WASATCH REGIONAL LANDFILL

MUNICIPAL SOLID WASTE LANDFILL PERMIT MODIFICATION

DESIGN ENGINEERING REPORT

RE: Updated Closure and Post-Closure Tables

II-6

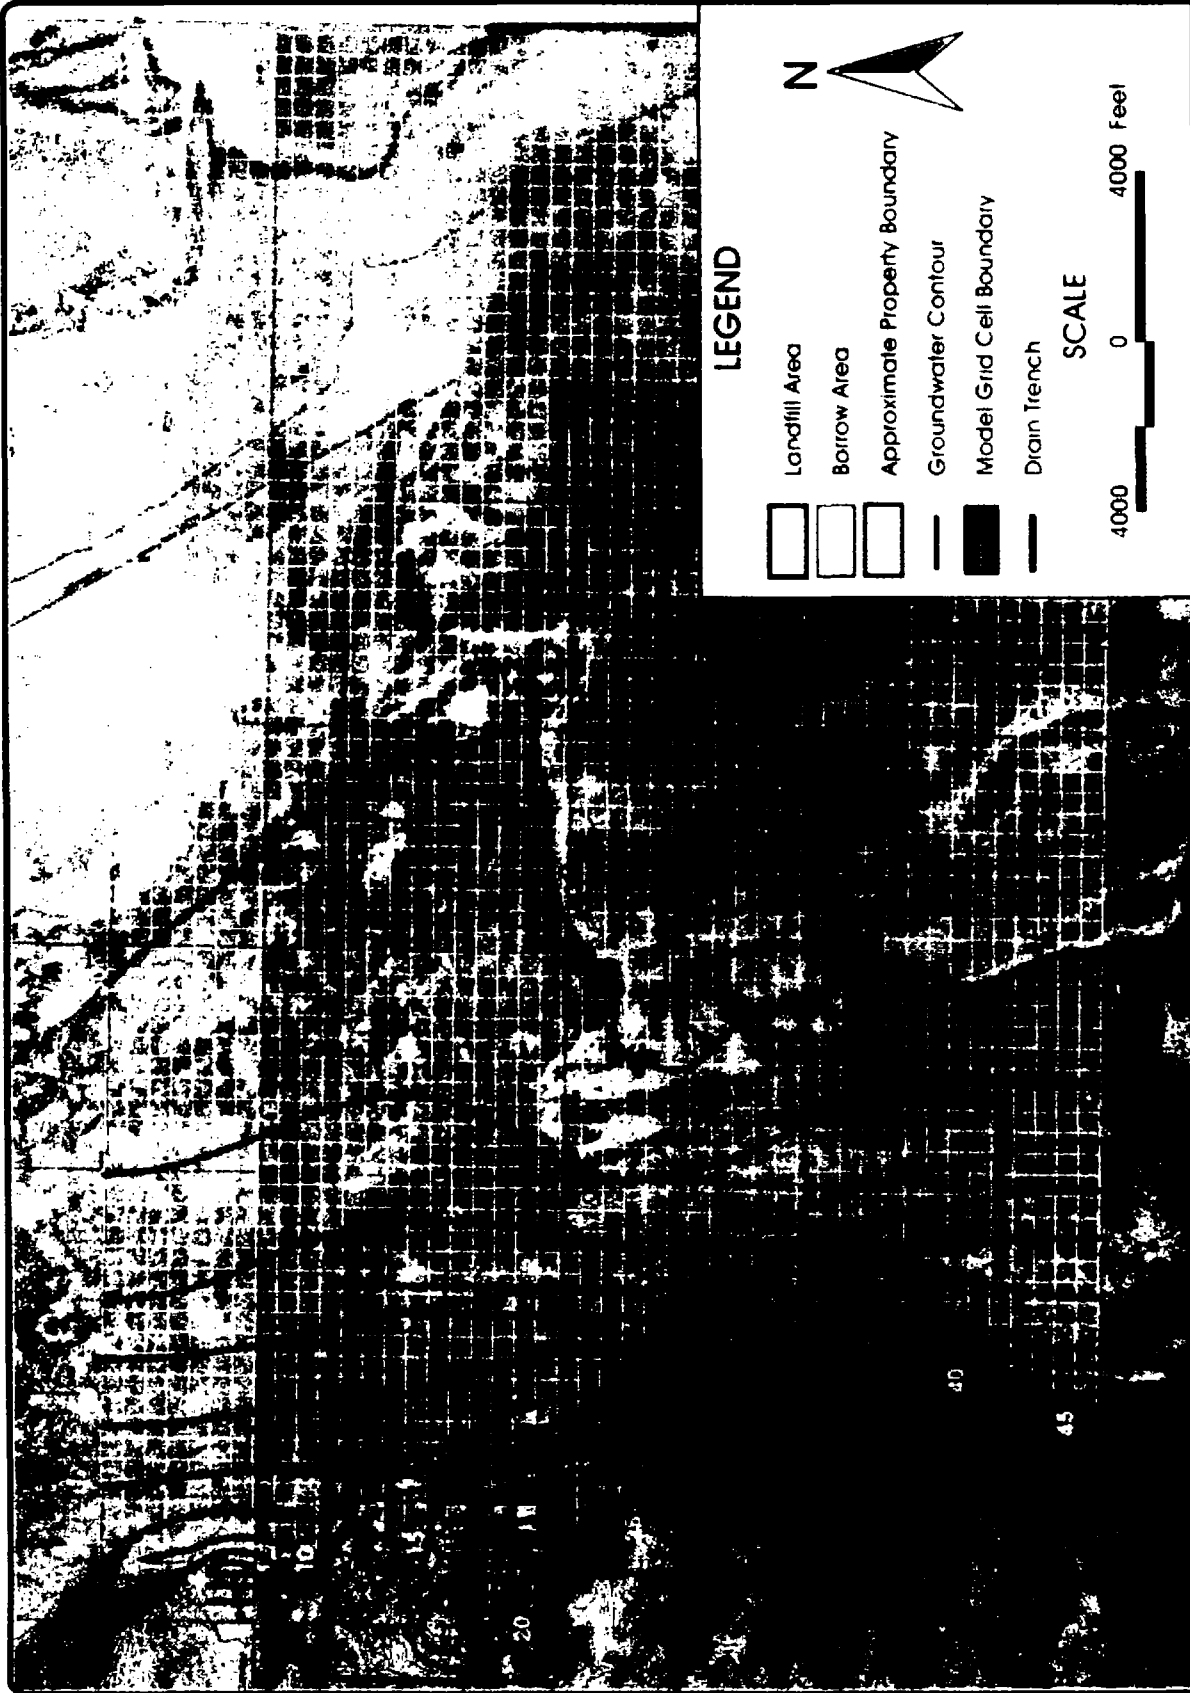
NOTE: Attached are revised Figures II-6 and II-7 representing projected ground water contours with the modified drain trench location to replace the original figures.

SHEET
4
113-30-100

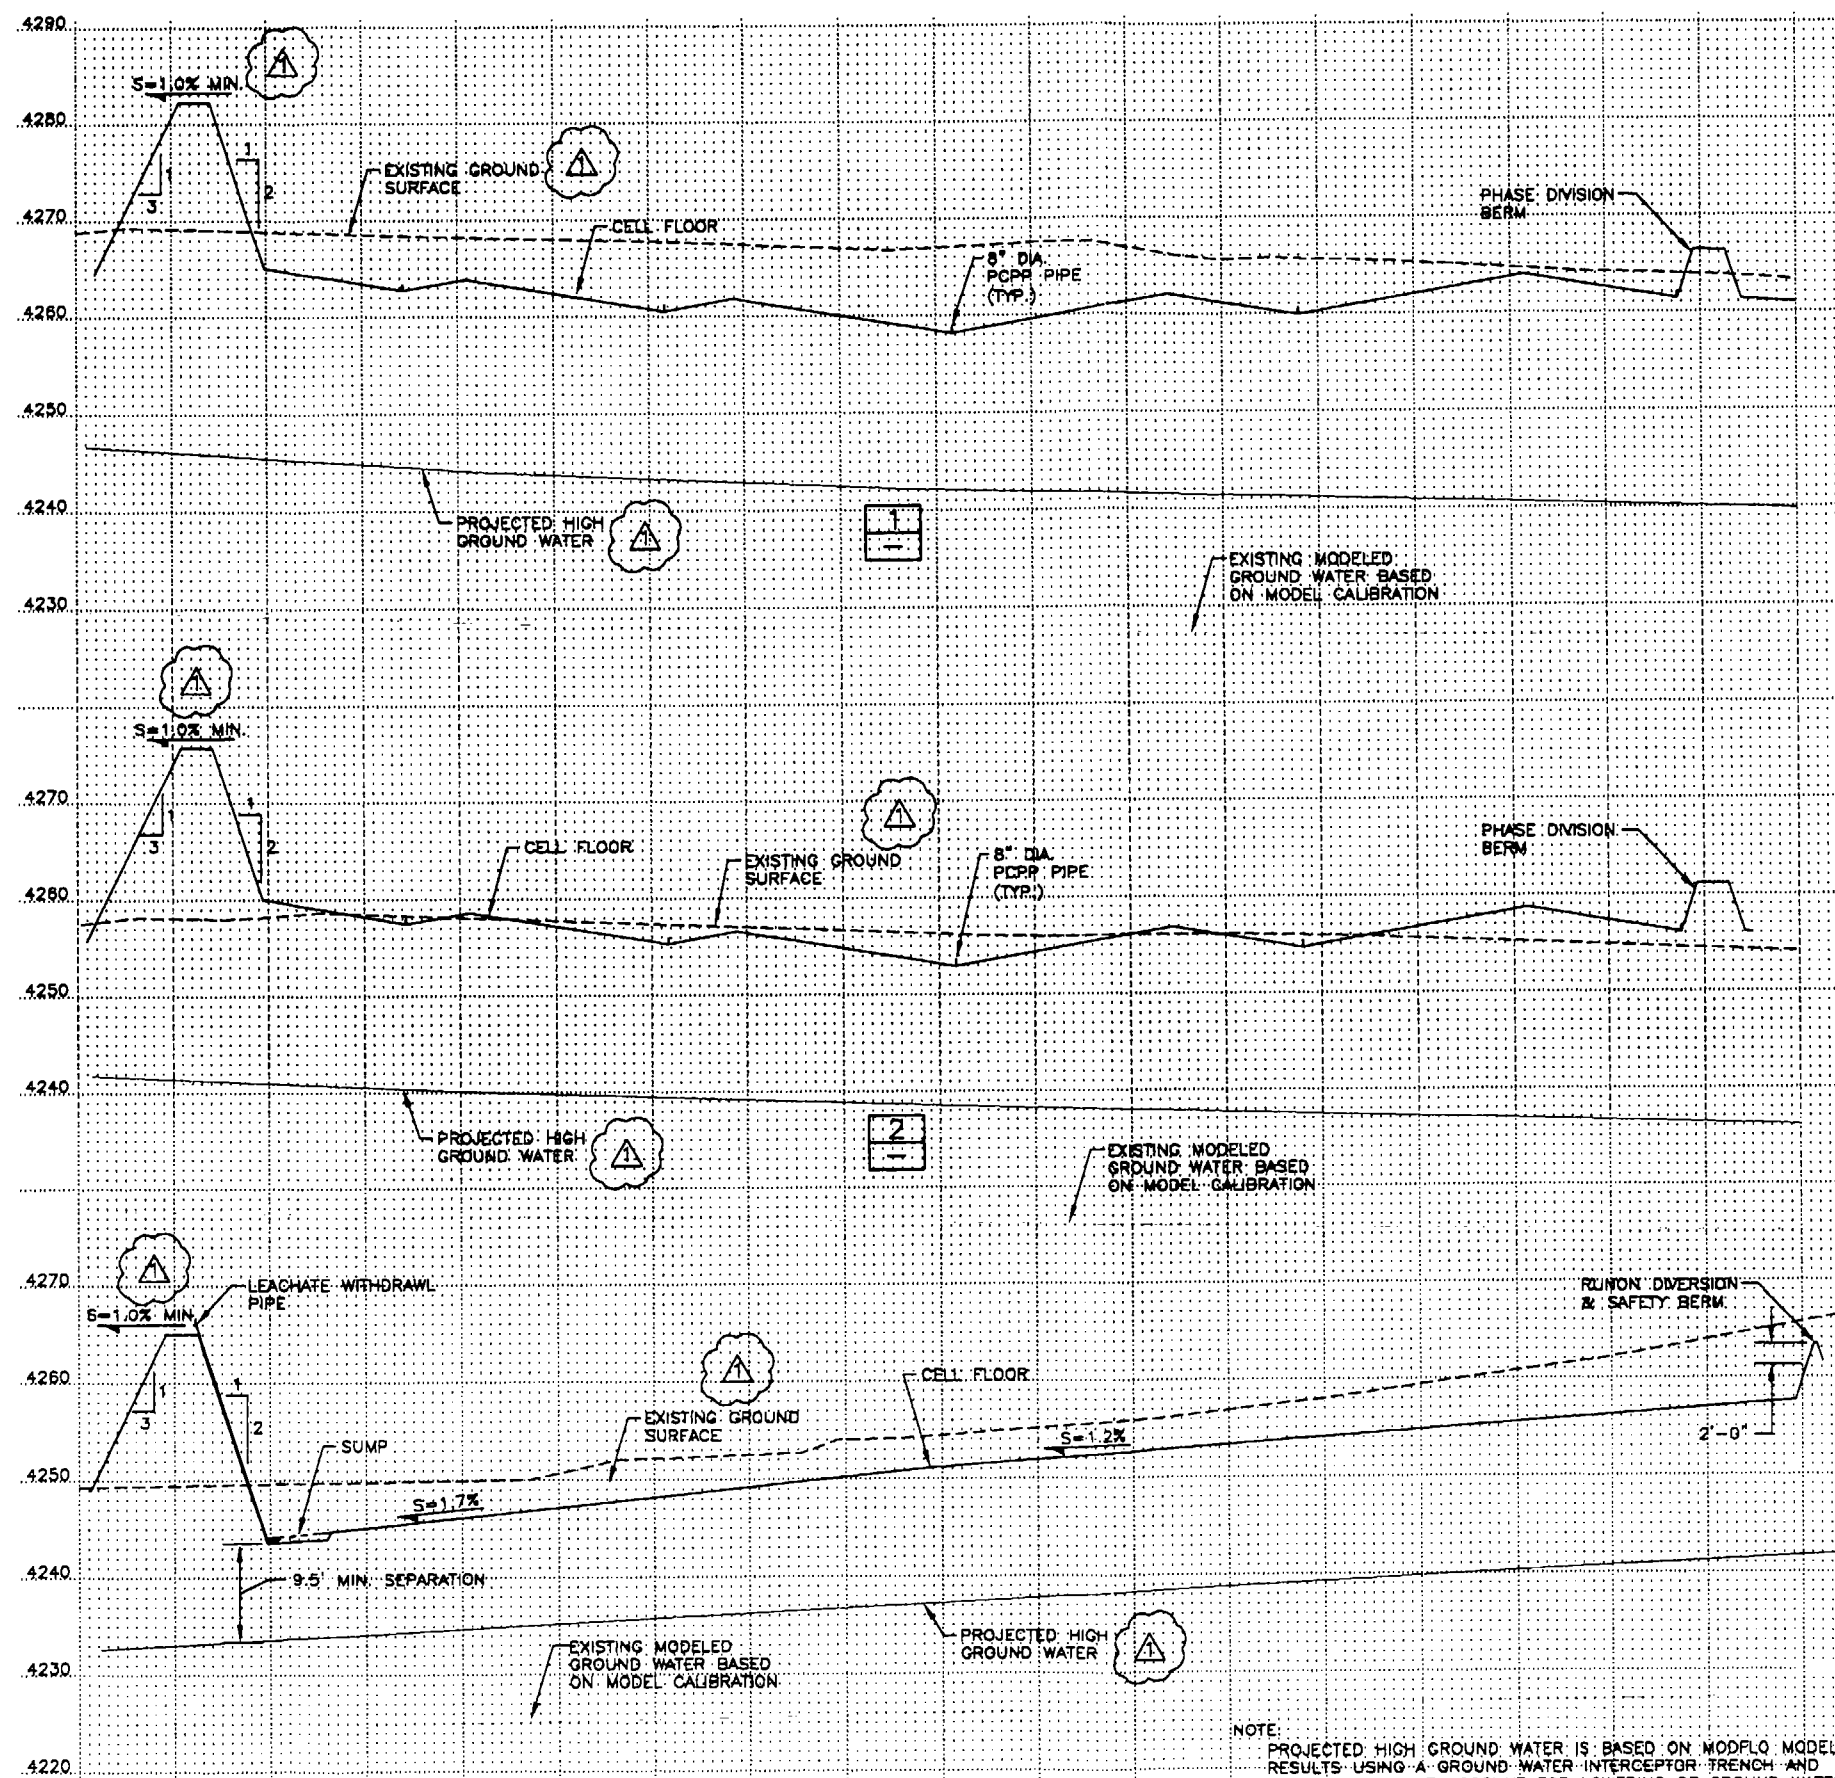
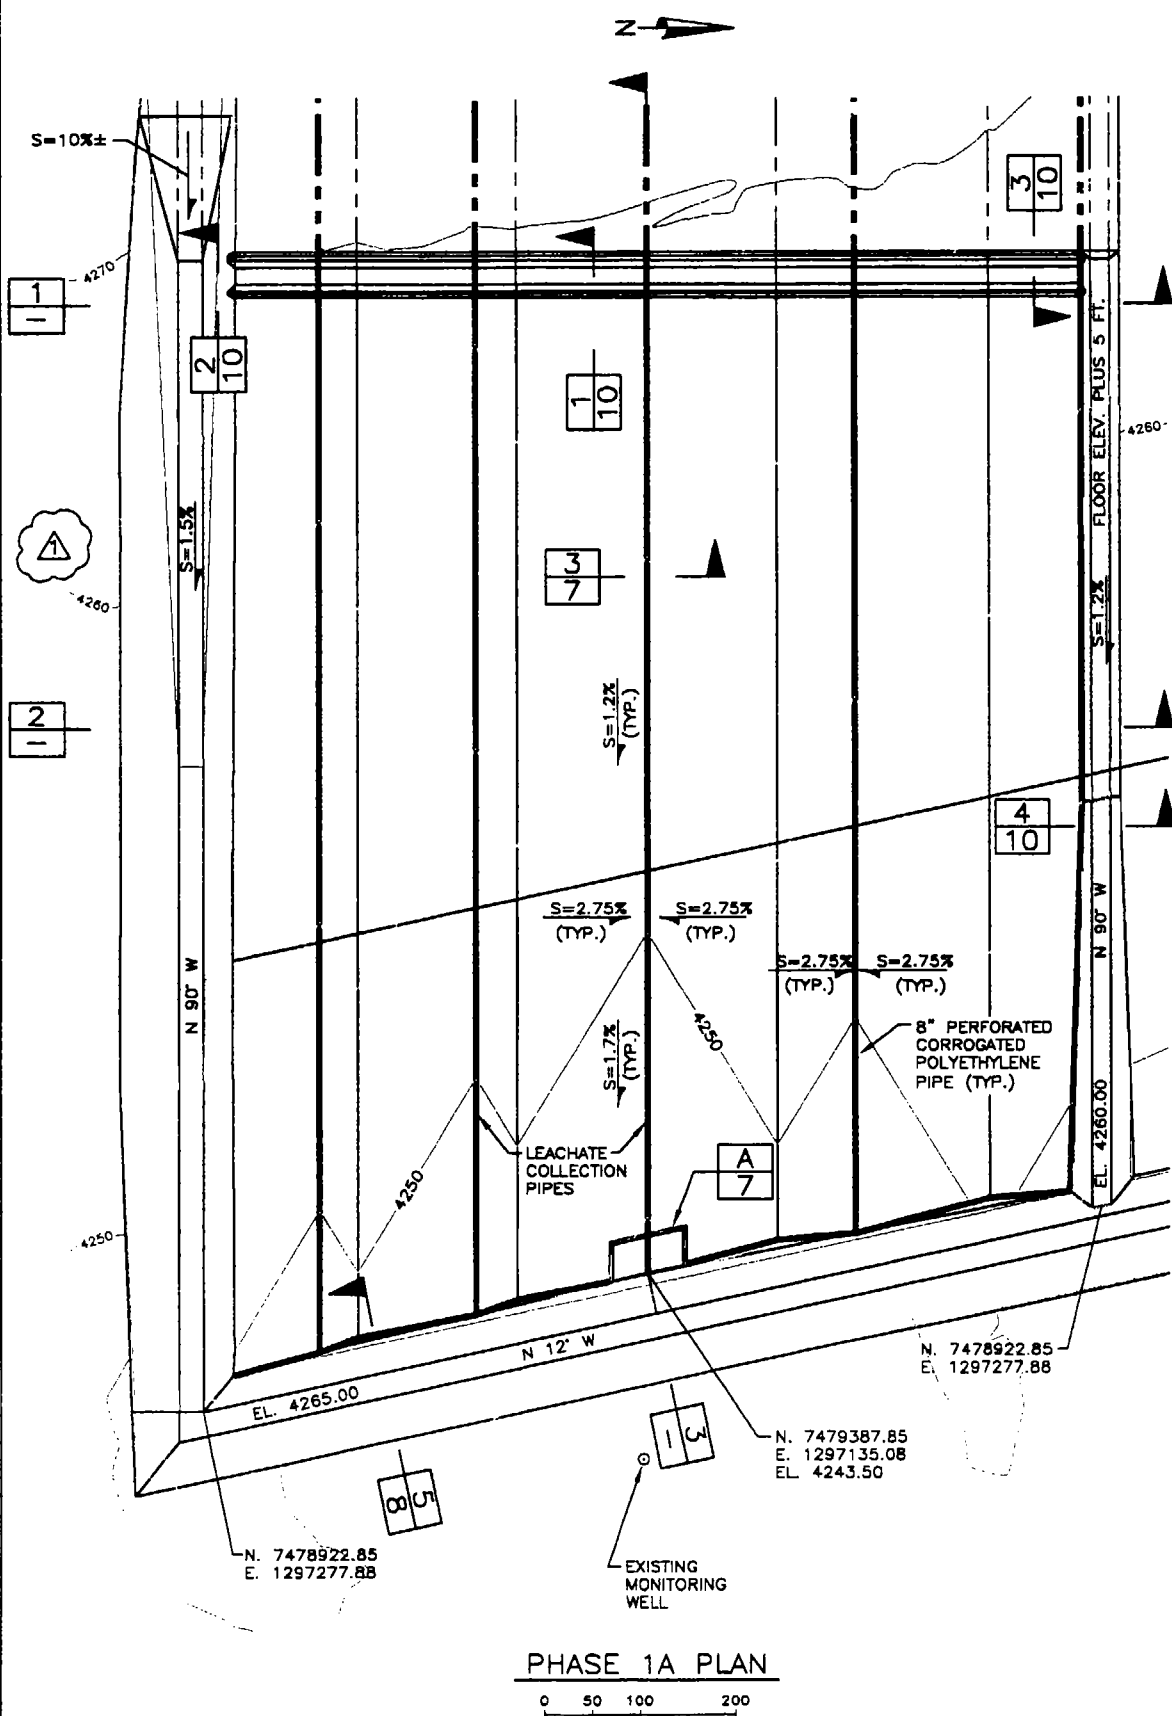
Sheets 3 and 4 of the drawings have been modified to show an additional monitoring well located approximately 500 feet to the west of the interior northeast corner of the landfill (along the north side of Phase 11).

Cross-section 8 on Sheet 4 has been added to show the tie-in.

CELL PHASE DIVISION BERM 4
N.T.S. 6

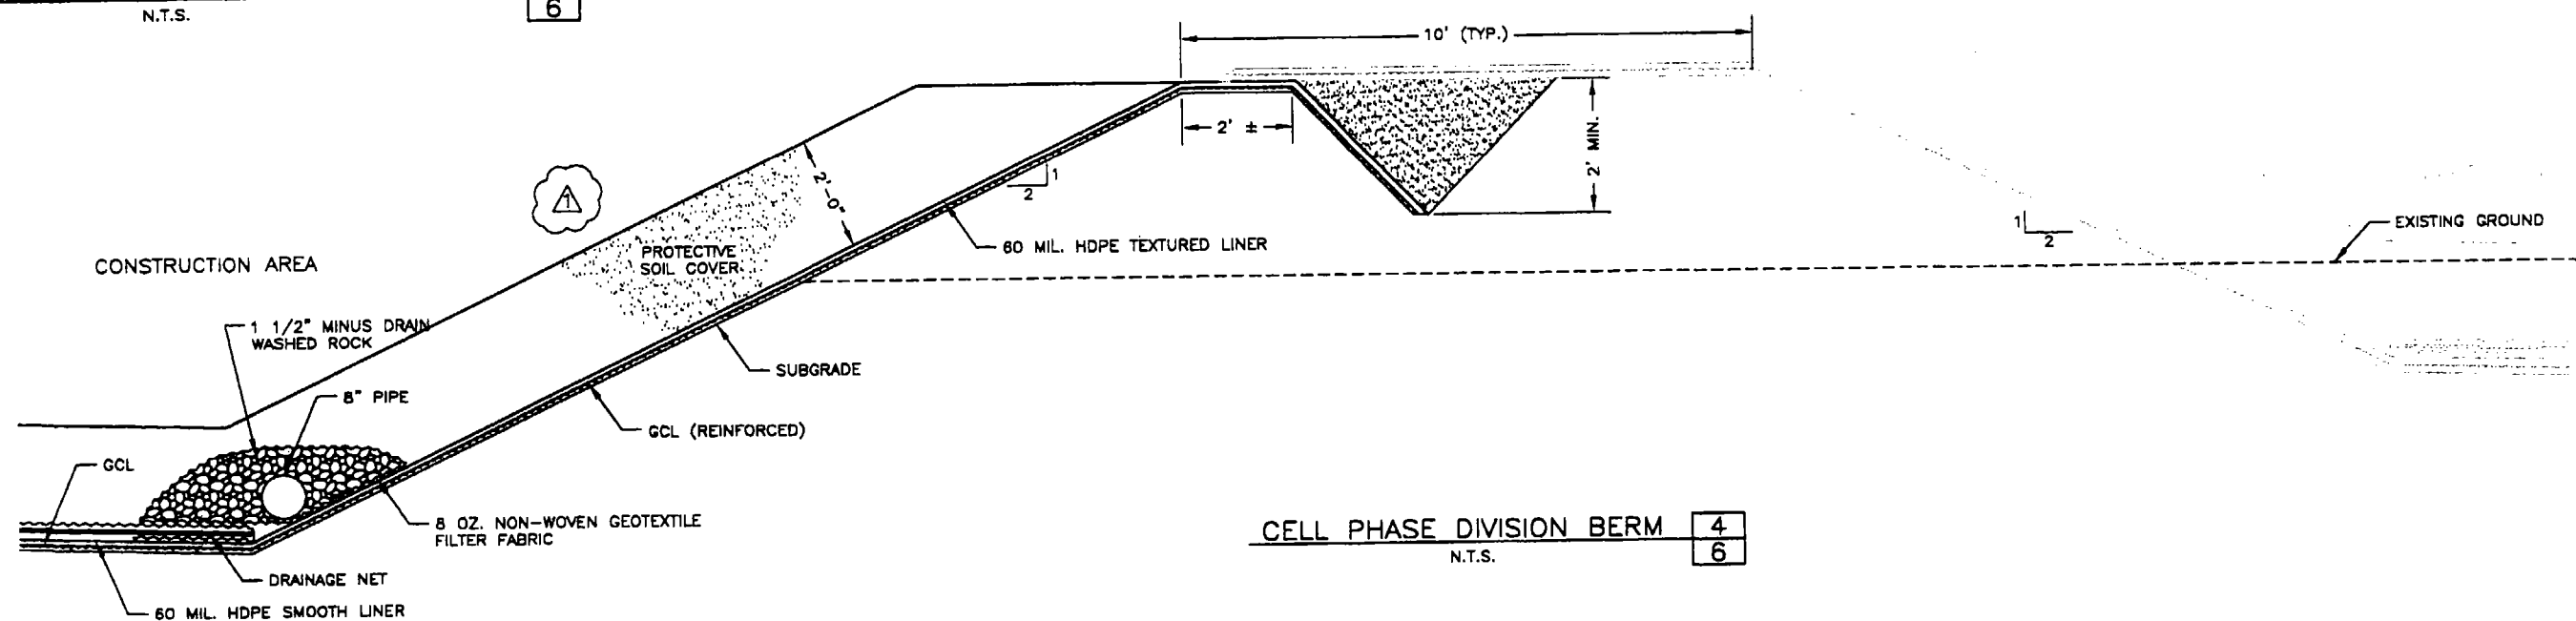
Sheet 10 Cell Phase Division Berm shows no anchor for the future cell liner.
